Project Name: **Westerlea View Lofts: 54 unit residential development plus 1 commercial space**
Project ID: #2016-184 (Subdivision & Site Plan) and
#2016-185 (Conditional Use Inclusionary Zoning)
Address: 75 Chestnut Street CBL: 26/E/10
Applicant: A&M Partners Inc
Planner: Jean Fraser

Subject: B7 Design Review – 75 Chestnut Street

Date of Review: Monday, December 5, 2016

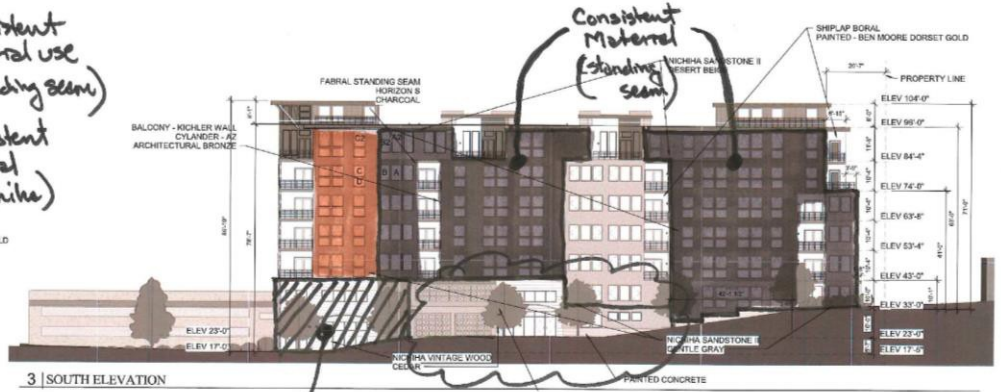
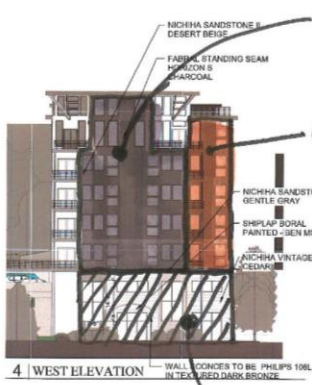
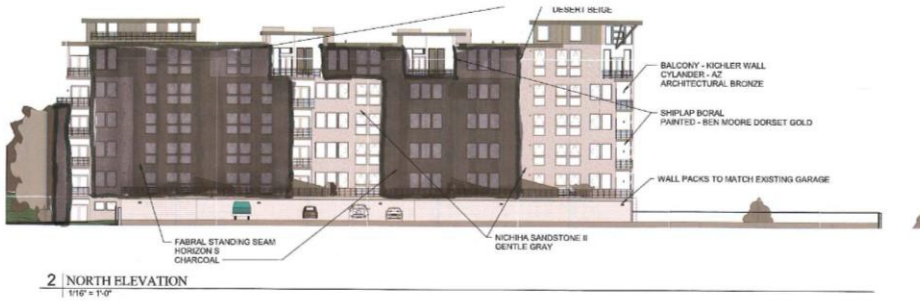
- Overall, staff does not find the placement of materials to be contextual. In some cases, the materials correspond to the massing or use, but in other cases, materials change at corners or in arbitrary ways that result in a patchwork quilt effect that does not benefit the overall design nor does it relate to the pattern or use of materials in the context. Staff recommends a simplification of material placement (example below). Visual interest should be achieved through articulation rather than a material pastiche.

- As stated above, little to no massing or façade variation is used to differentiate the ground floor – the result is a flat façade for the full 6 stories of the building.

- The base of the building should be more consistently defined, especially on the Chestnut Street side. At this point, that can best be achieved through articulation, material placement and detailing. The corner, double-height live-work unit could also be more substantially differentiated from the other masses of the building.

- The level of detail and articulation on the Chestnut Street elevation is not sufficient, especially at the street level. Material changes are mostly arbitrary and other than at the entrance, do not correspond to uses or plane changes. Revisions to meet this standard could come in form of enclosure; articulation and detail (reveals, dimensional trim, material transitions, detail); placement of material that corresponds with uses

Consistent material use (standing seam)
Consistent material (Nichha)

Consistent Material (standing seam)

Consistent material use differentiating this corner unit

Ped level articulation + match floor plans
